**From:** Lauren McMahon <lmcmahon@mecone.com.au>  
**Sent:** Wednesday, 1 November 2017 1:32 PM  
**To:** Aditi Coomar  
**Subject:** Re: Modification to Redevelopment of Parramatta Public and Arthur Phillip High Schools - Request additional information  
**Attachments:** Re: APHS: s96 modification of material to the gym

**Subject:** Modification to Redevelopment of Parramatta Public and Arthur Phillip High Schools - Request additional information

I refer to the above application and advise that the proposed modification has been referred to EPA, OEH, Parramatta Council and Heritage Council for comments. Consequently, the following information is requested by the Department and by EPA prior to further assessment being undertaken:

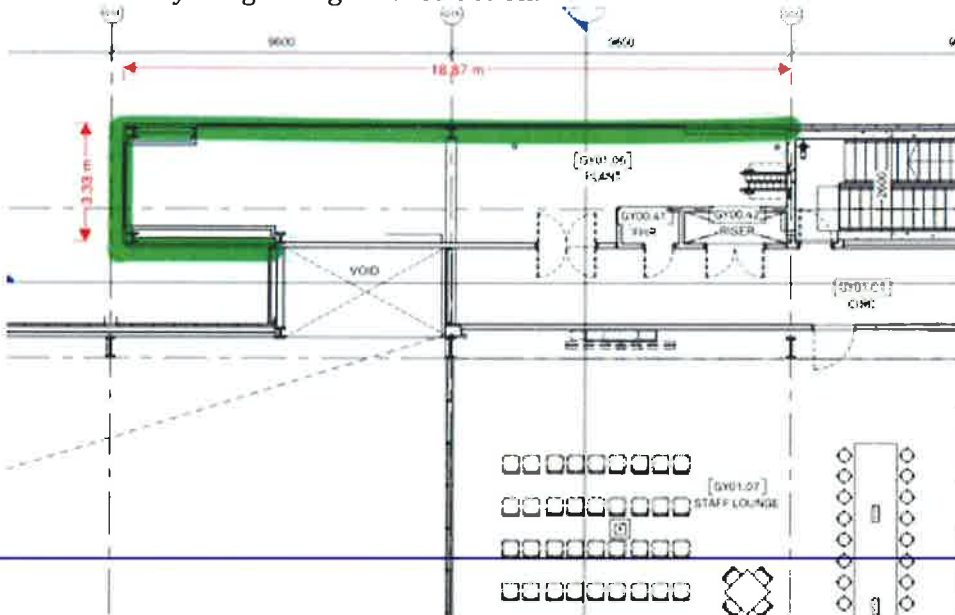
(a) substituting metal for masonry cladding of part of the Arthur Phillip High School gymnasium which may influence the character, quality and level of noise impacts on

Based on our conversation today, I understand that the section of façade highlighted below is being changed from masonry to lightweight construction.

surrounding noise sensitive land uses, particularly during use of those facilities outside school hours, and Our Acoustic Consultants (ARUP) have looked at the amendments to the material to the APHS gym, see attached correspondence. ARUP states that the noise levels at the nearest external receiver meet the project criteria.

- 1) Noise breakout from the spaces adjoining that façade on the Upper Ground level aren't of concern, given the intended usage (Store rooms, First Aid).
- 2) We've updated our noise breakout calcs for the plantroom adjoining that façade on Level 1, incorporating the proposed façade build-up (4mm metal sheet | 248mm cavity with 50mm fibreglass insulation (18kg/m<sup>3</sup>) | 13mm plasterboard). Noise levels at the nearest external receiver meet the project criteria.

So the proposed lightweight façade construction is acceptable.
